RESOLUTION

Vacation/Discontinuance of two portions of Kilpatrick Lane
(SEE ATTACHED)

Resolution: RES-13-00197

RE: Approval of a final plat creating 18 single-family lots, 4 lots for future mixed-use development, 1 lot for a future City library, and 2 outlots for private open space, all generally located at 6002 Cottage Grove Road and 5901-5939 Sharpsburg Drive in the Grandview Commons development (Jeff Rosenberg, Veridian).

TOWN CENTER ADDITION TO GRANDVIEW COMMONS

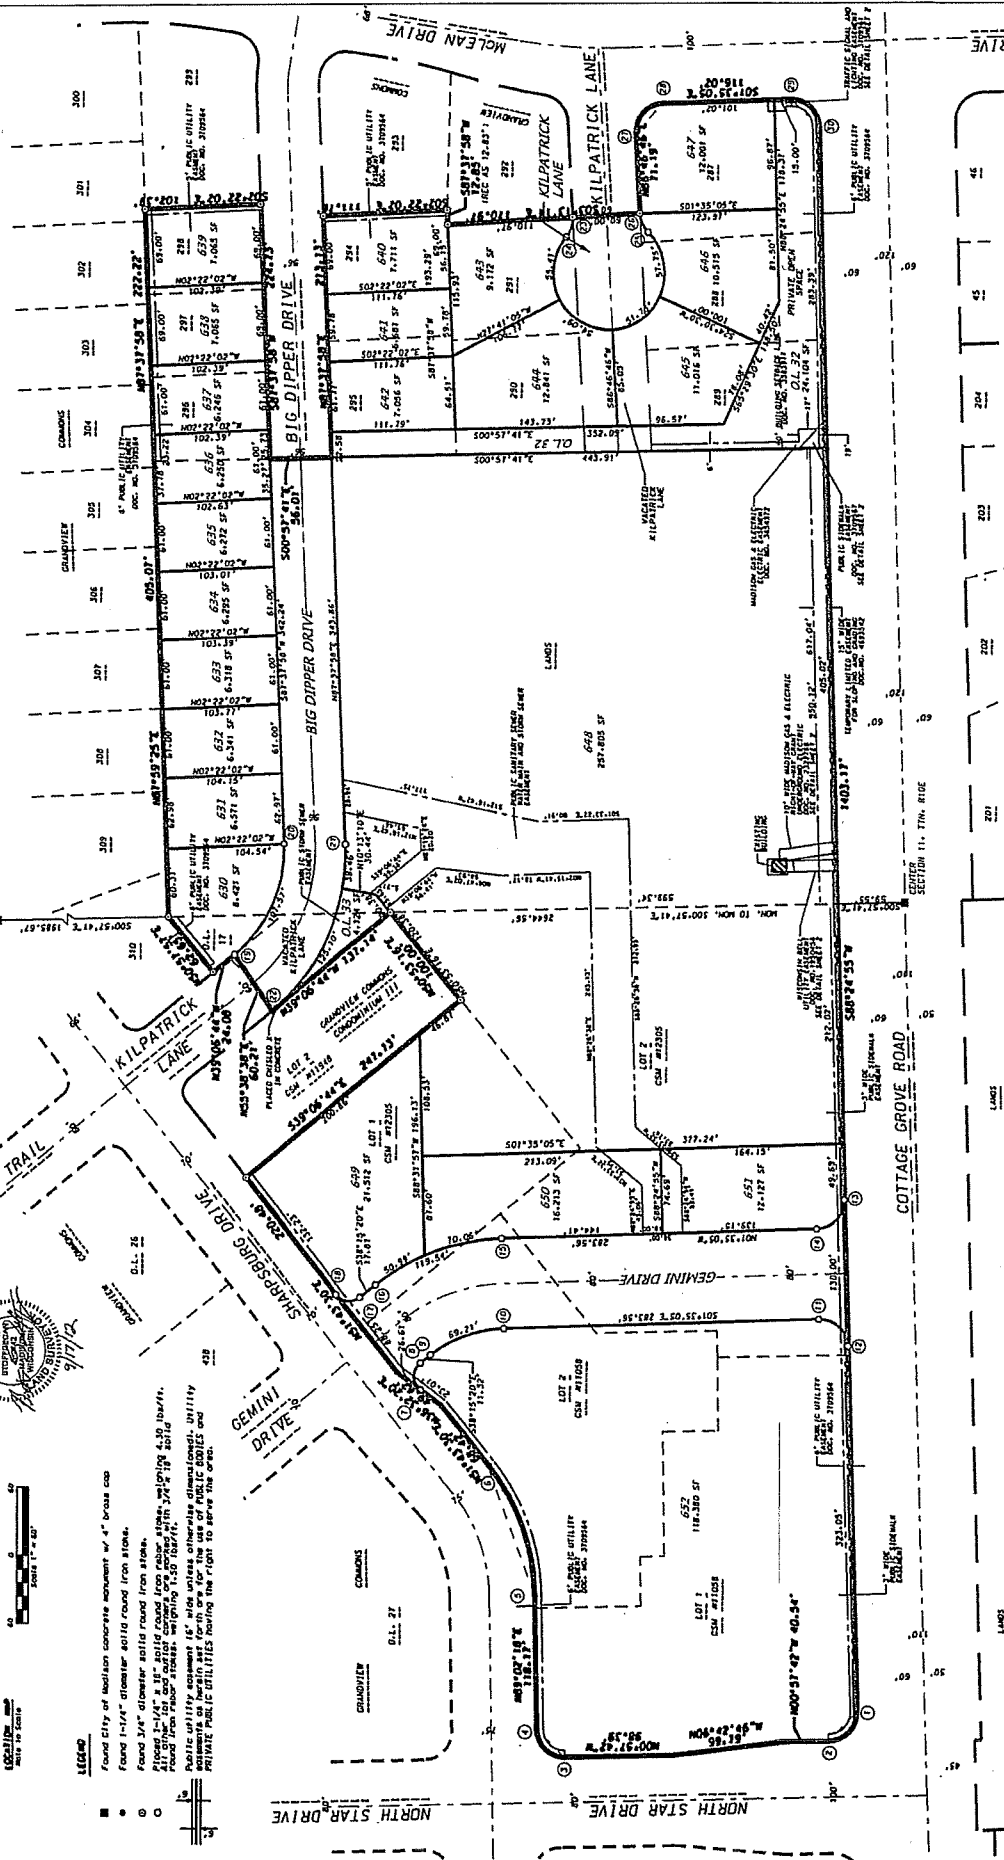
45. That the final plat be revised prior to final approval for recording as follows:
 - a.) Include on the final plat a complete and accurate legal description of the lands that are to be included in the proposed plat. The legal description shall be reconciled with the legal description of said lands in record title.

- b.) Include a note on the final plat that some of the lands within the plat boundary are subject to additional terms of Special Warranty Deeds recorded as Document Nos. 4897646, 4897643, 4897649 and 4897639.

- c.) Include a note that some of the lands within the plat boundary are subject to plans recorded as Document No. 4931251.
 - d.) Extend the 40-foot setback line through proposed Lots 648, 651 & 652 per the plat of Grandview Commons, as well as CSM 12305 & 11058.

- e.) Remove Document No. 3872555 from Note 2B on Sheet 2, which is shown twice.
 - f.) Update Note 3 to state "Lots 630-647", if "617" is a typo.
 - g.) Depict and label the access restricted areas on the final plat, per prior plat and Certified Survey Maps.

- h.) Depict the easement shown in Exhibit A of Document No. 4362638

- i.) Update the labeling of Outlot 33 to match the description in Note 10 on Sheet 2.
- j.) Correct typo in Note 9 on Sheet 2.
- k.) Depict and label the easement shown in Exhibit A of Document No. 4329450. If this easement has been released, please provide the recording information for the document that does so.
